CALIFORNIA COASTAL COMMISSION

RECORD PACKET COPY**STAFF REPORT: REGULAR CALENDAR****APPLICATION NUMBER: 5-00-034****APPLICANT: Mike McKinley and John Bass****AGENT: Alan Block****PROJECT LOCATION: 327 and 327 1/2 Paseo de Cristobal, City of San Clemente, Orange County**

PROJECT DESCRIPTION: To permanently authorize the construction allowed under Emergency Permit 5-98-273-G for a new 110 foot long by twenty foot tall retaining wall with sixteen caissons on a coastal bluff and backfilling the area between the retaining wall and the landslide scarp with approximately 1600 cubic yards of material on two lots totaling 26,481 square feet. Re-landscaping the bluff below the retaining wall with native vegetation and the construction of new backyard hardscape on both lots.

BASS/MCKINLEY RESIDENCES

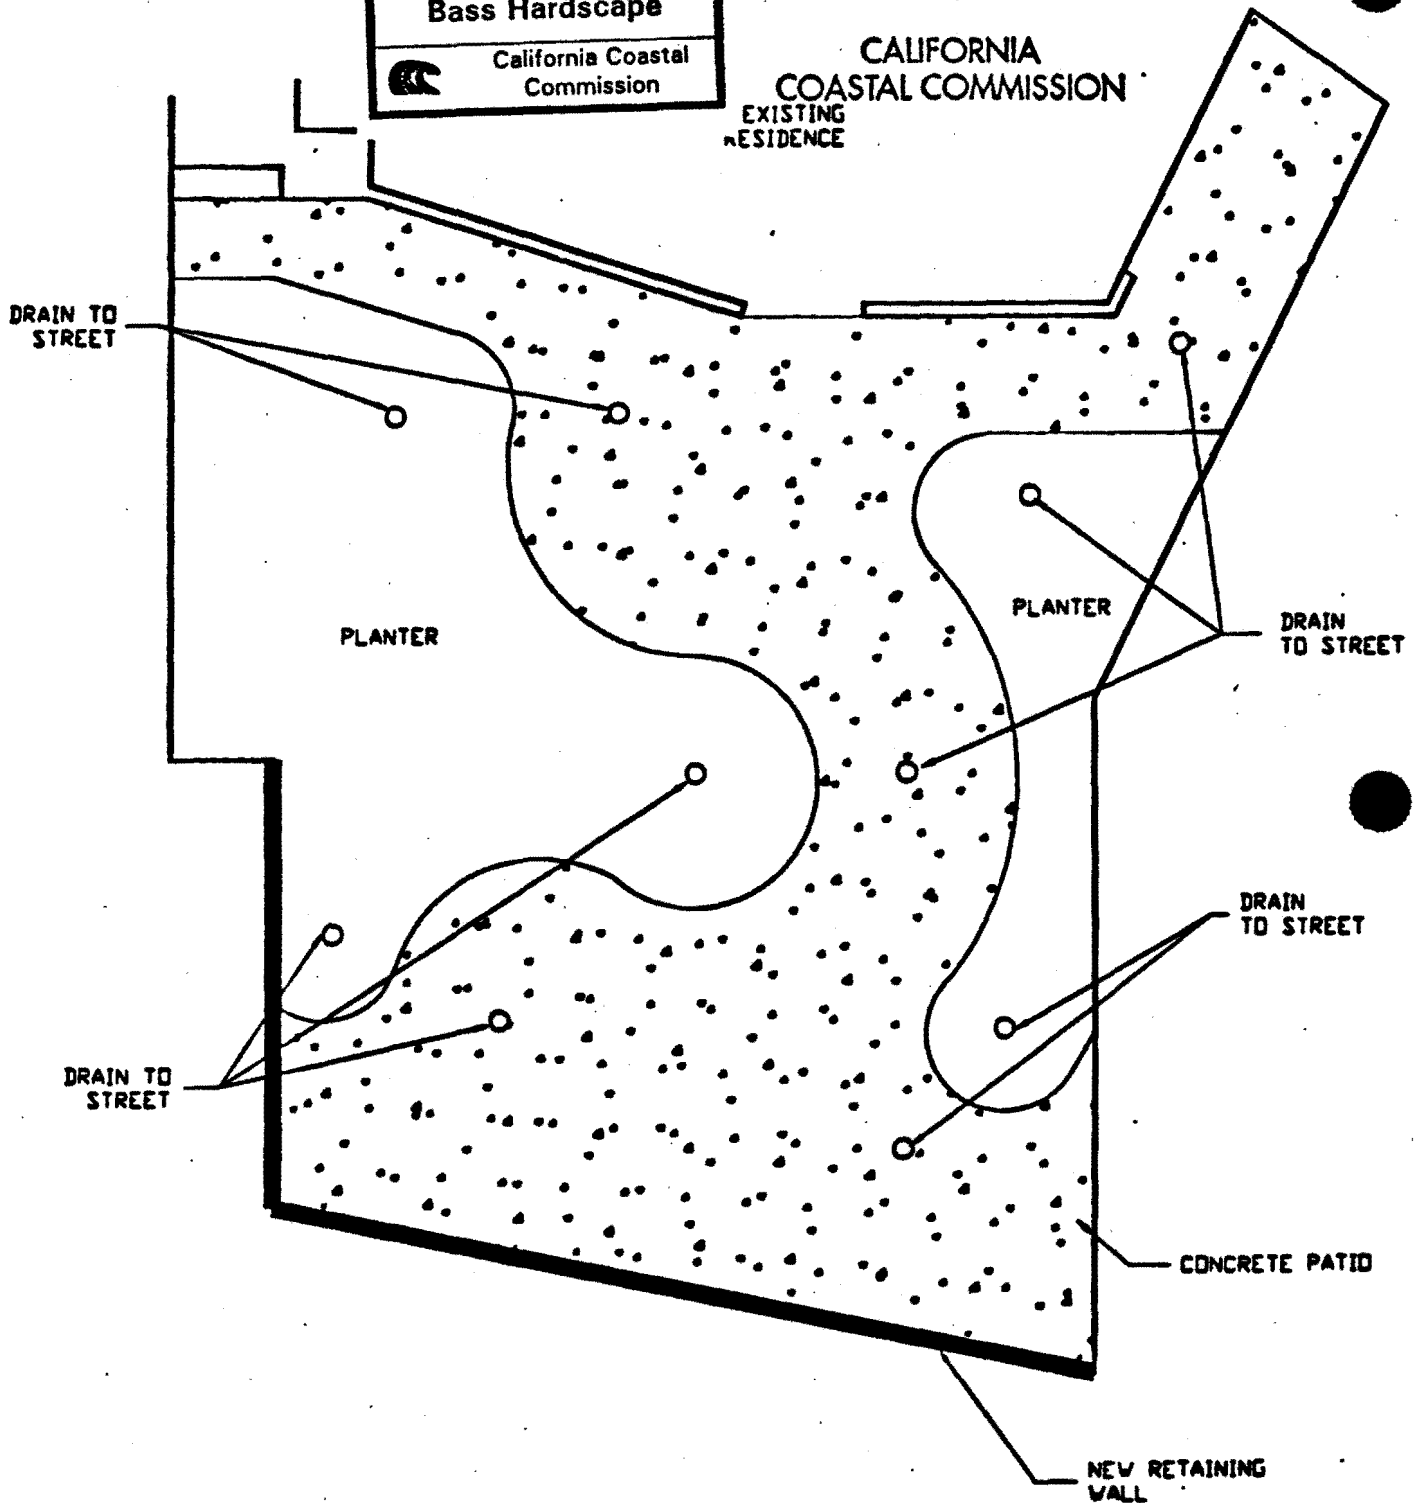
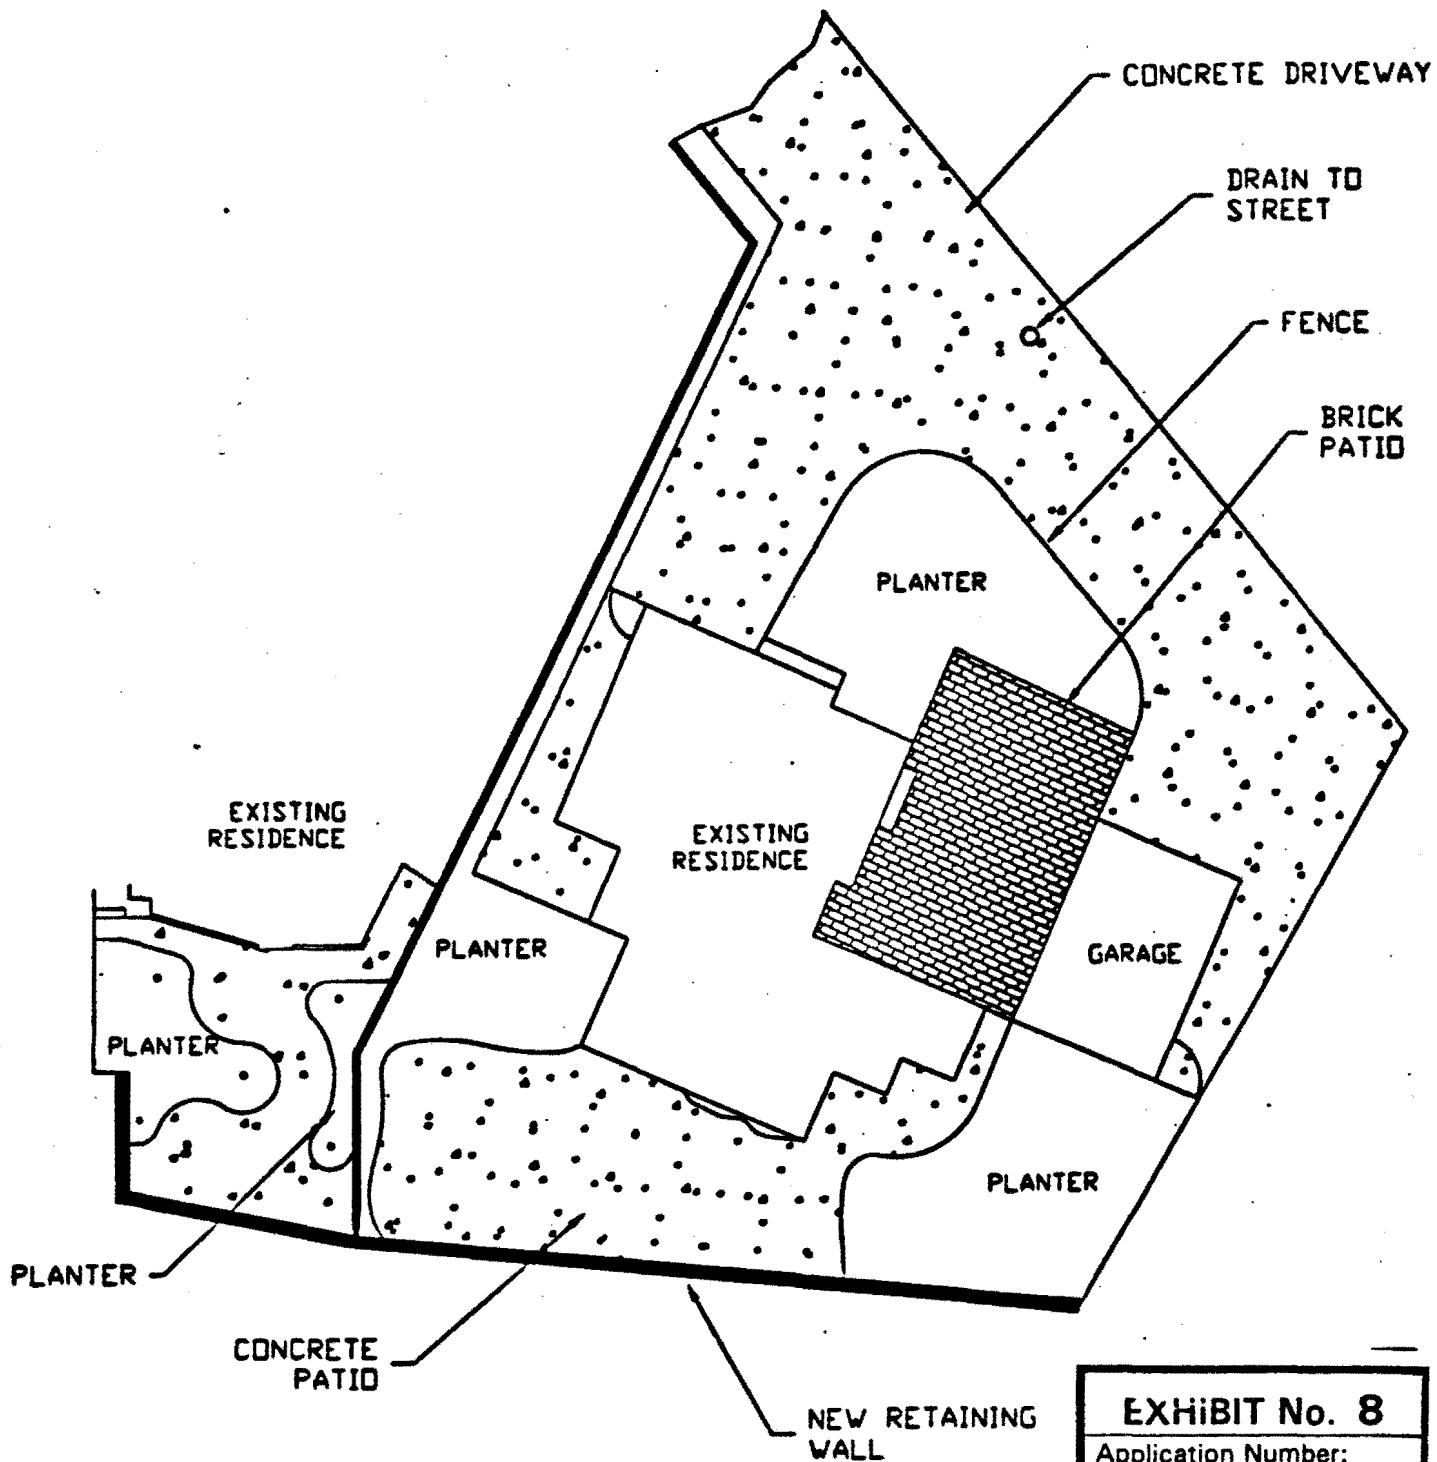
- b. Landscaped areas in the front and side yards can include non-native potted ornamental plants provided that they are non-invasive, are placed on drained hardscape, and do not allow water to percolate into the soil. Vegetation installed in the ground shall consist of native drought tolerant plants.**

- c. No permanent irrigation system shall be allowed within either property. Temporary above ground irrigation to allow the establishment of the plantings is allowed.**

Landscaping Plan

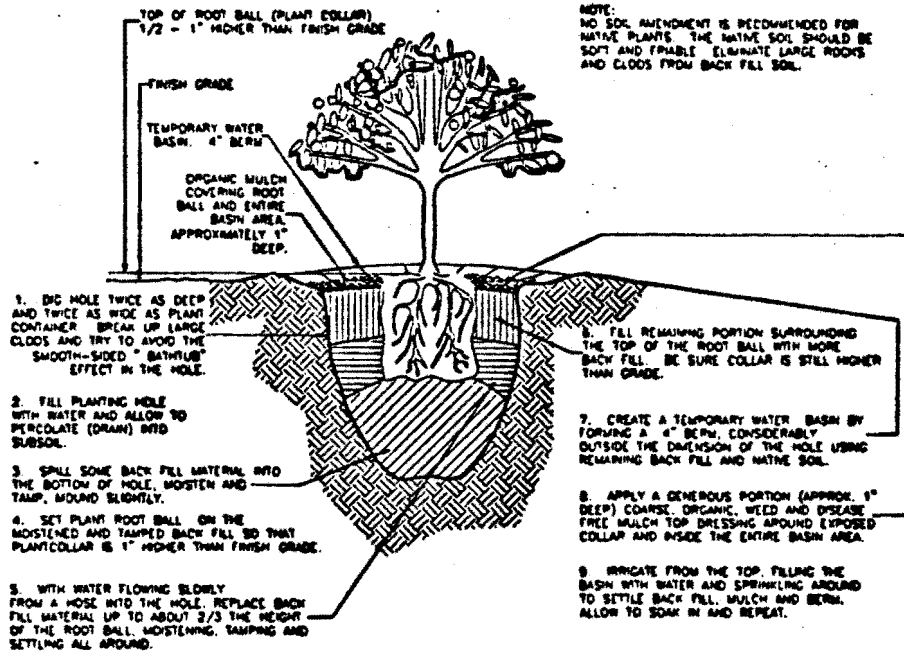
The Commission's coastal engineer (Exhibit 15) has reviewed the irrigation plan and found that it does not provide site-specific information nor will it provide any site specific feedback between evapotranspiration and irrigation water applied. While the Commission has approved irrigation plans for areas with an identified potential for landslides, such as at the Ocean Trails Golf Course and Pepperdine University, these plans have incorporated moisture sensors and feedback mechanisms that are continuously monitored by computer and ensure that the irrigation volumes carefully match evapotranspiration rates and soil saturation. The only feedback mechanism proposed for this property is *"during periods of intense or prolonged rainfall, irrigation should be curtailed until the vegetation begins to show signs of distress."*

The Commission's coastal engineer concluded that the soil cap which is near the surface should prevent percolation of surface water into the backfill material. The current plan to provide general site irrigation of 32.6 inches annually could over-irrigate the site whenever the yearly rainfall exceeds 11.8 inches. In addition to potential saturation from irrigation, the backfill material would still be subject to potential saturation through the infiltration of groundwater traveling under the soil cap. While a detailed monitoring and irrigation plan may be beneficial in maintaining the long-term integrity of the soil cap, the proposed plan neither demonstrates that

To minimize the potential for a future slide a landscaping plan, shall be prepared by a licensed landscape architect and shall incorporate the following criteria: 1) to minimize the introduction of water into the ground, no permanent in-ground irrigation shall be permitted on either property (temporary above ground irrigation to establish the plantings is permitted); 2) landscaping installed in the ground shall consist of native plants. The side yards and front yards can contain non-native drought tolerant plants provided that the plants are in pots and are placed on drained hardscape which does not allow water to percolate into the soil, and 3)

Invasive, non-indigenous plant species which tend to supplant native species shall not be used. Additionally, the landscaping plan shall show the existing plants and irrigation system. Any existing irrigation shall be capped and disconnected. Through this special condition, one of the contributing factors to bluff failure, the introduction of water into the ground, will be minimized.
